IEEE802.3bt
LLDP adhoc

Meeting #9: Tuesday August 22, 2017

- **The purpose** of this ad-hoc is to resolve LLDP state machine related comments from D2.4 and related issues for PSE and PDs prior sponsor ballot for D3.0.

Annex A: Why we need $Y=A+B$ as currently in the spec? -2

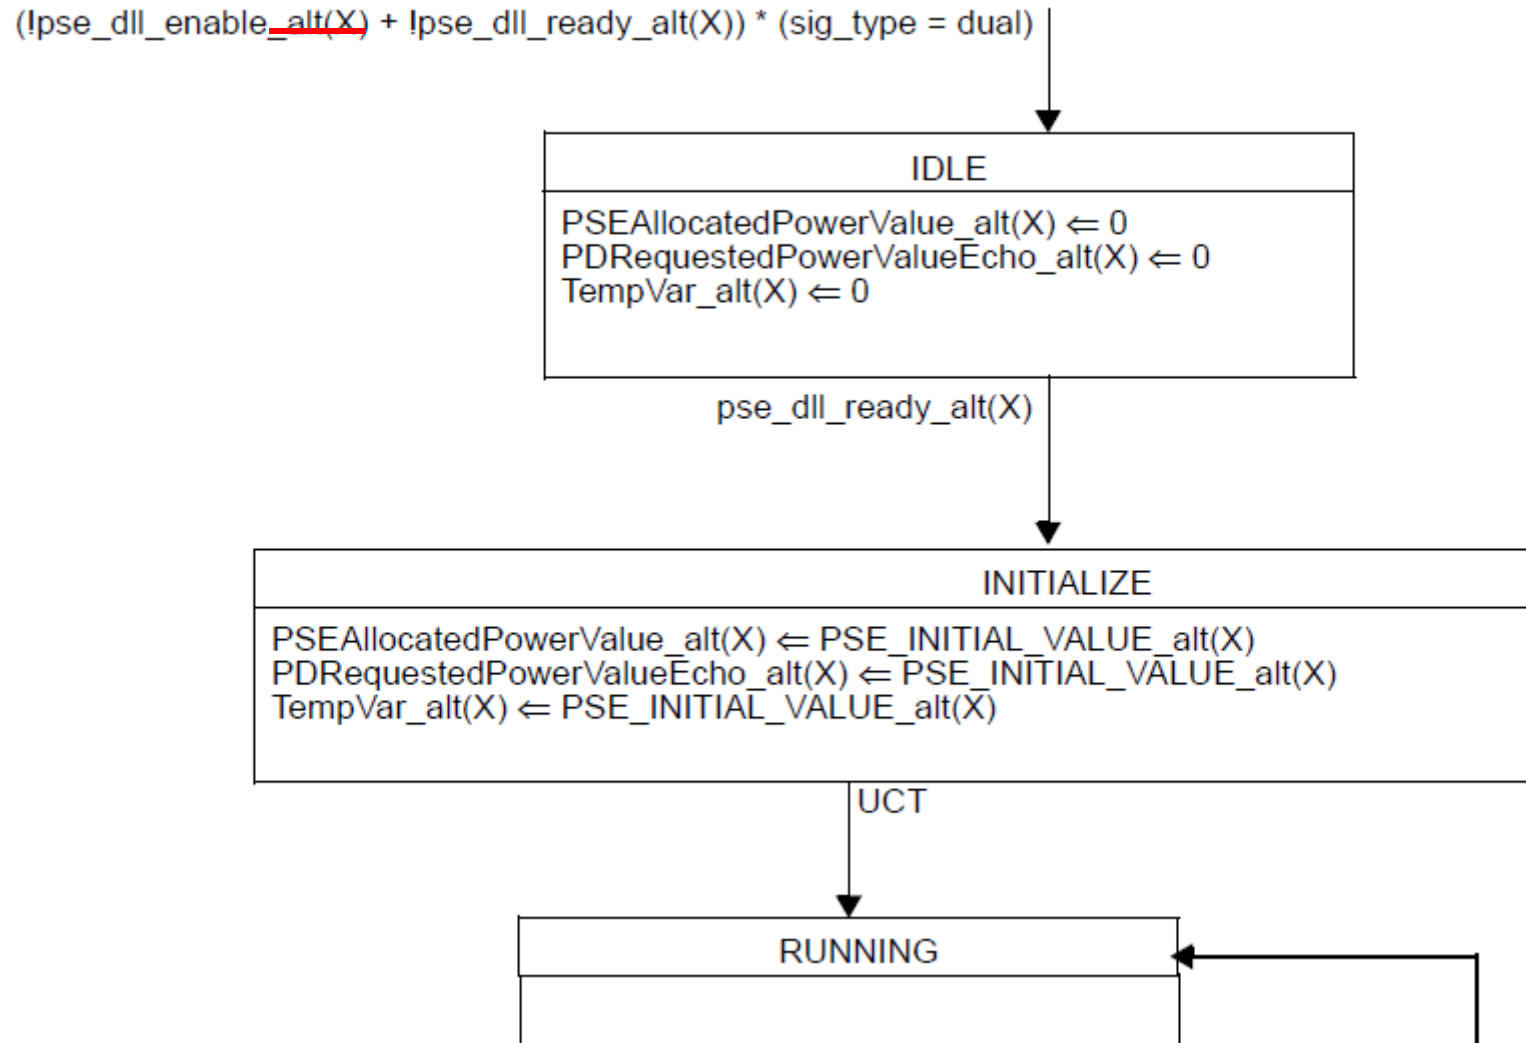
- Argument #3

High level power management care only for the total port power. The power management per pairset is kind of sublayer of the power management system. It is useful to pass the total power through the TLVs field. This is in general how current PSEs systems works.

Other alternative solution to this problem is to use the field “PSE max available power” which should be the total port power. We need to clarify in 79.3.2.6e that this value is applicable for PSE that supports single-signature and dual-signature.

Annex B: Comment #297 D2.4 (Page 75 line 12 in D2.5) - Figure 145-43 Meeting #8: Group is OK

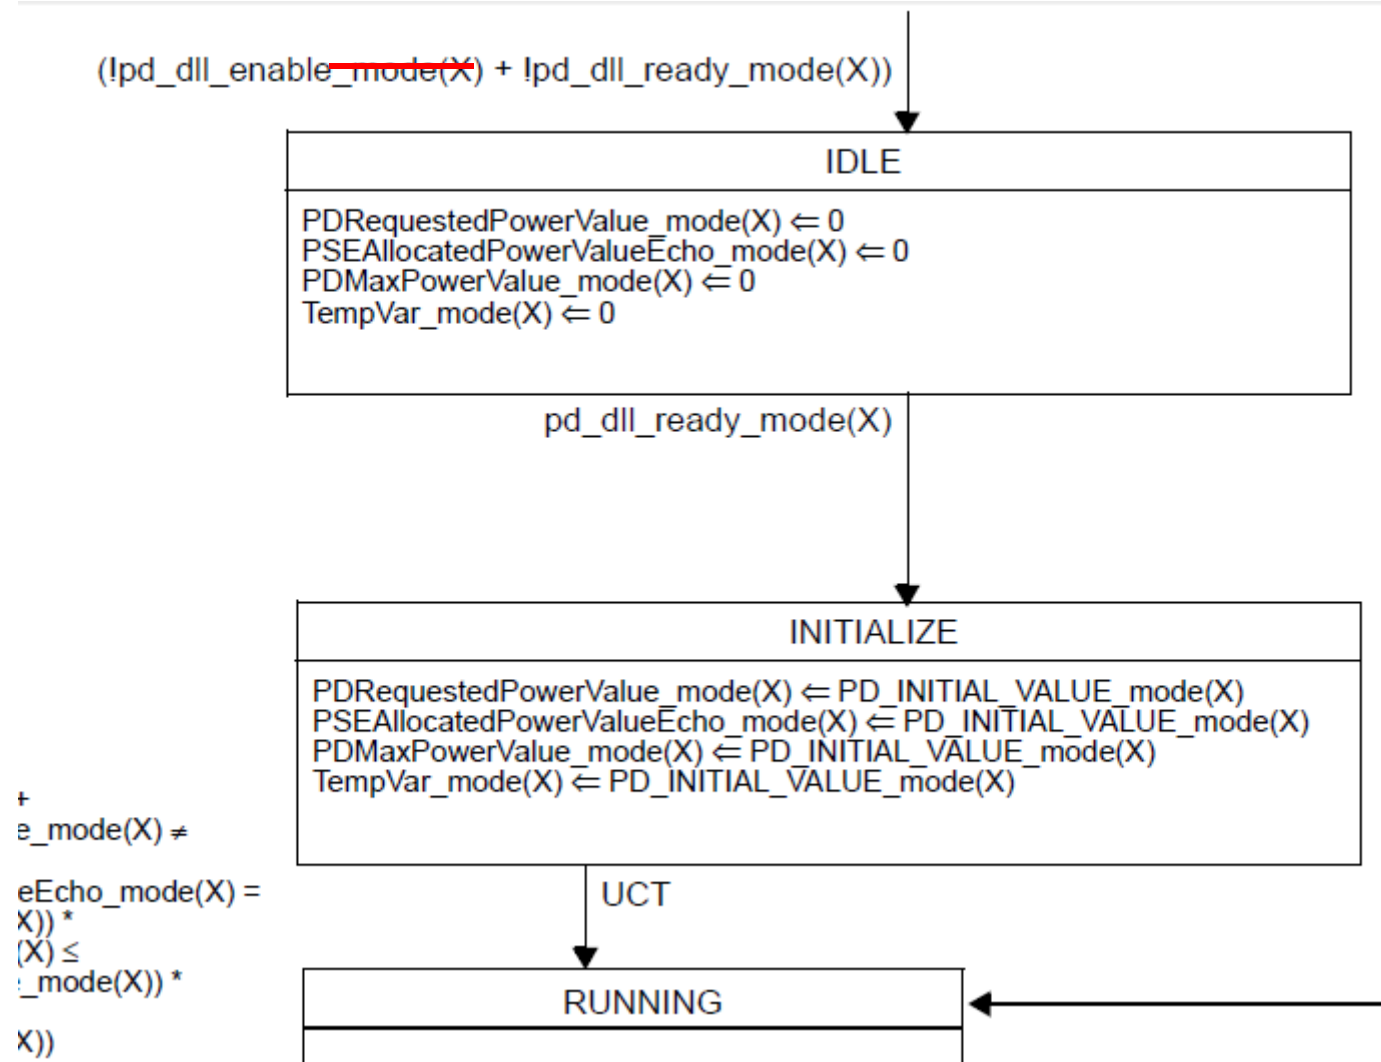
- Comment #297 D2.4 (D2.5 Page 78 line 46)

"If Mode (X) is non-active while the other mode is active, the inactive PD requested power value Mode (X) field value shall be set to 0."

- What is this trying to do ? The PD may wish to ask for power on an unpowered Mode...

- In Figure 145-44 and Figure 145-45 power control state diagrams when connected to dual-signature PD, we add in D2.3 an IDLE state in order to resolve non active Alternative(X) or no active mode(X) by setting the relevant variables to zero prior going to INITIALIZE state.
 - Figure 145-45: PSEAllocatedPowerValue_alt(X), PDRequestedPowerValueEcho_alt(X) and TempVar_alt(X)
 - Figure 145-46: PDRequestedPowerValue_mode(X), PSEAllocatedPowerValueEcho_mode(X), PDMaxPowerValue_mode(X) and TempVar_mode(X)

- Yair it will work:
 - The proposal is:
 - To change from `pd_dll_ready_mode(X)` to `pd_dll_ready` in the PD state machine.
 - To change “if this mode/Alt is inactive, set to value 0” to “if this Alt is inactive, set to value 0” i.e. keep this requirement only to PSE.

- Lennart response: The proposed response to this comment is to adopt:
 - To change from `pd_dll_ready_mode(X)` to `pd_dll_ready` in the PD state machine.
 - To change “if this mode/Alt is inactive, set to value 0” to “if this Alt is inactive, set to value 0” i.e. keep this requirement only to PSE.
- **Group to discuss.**
- **GROUP OPINION? Group is OK.**
 - The modifications proposed to the state machine in Figure 145-43?
 - To change from `pd_dll_ready_mode(X)` to `pd_dll_ready` in the PD state machine.
 - To change “if this mode/Alt is inactive, set to value 0” to “if this Alt is inactive, set to value 0” i.e. keep this requirement only to PSE.
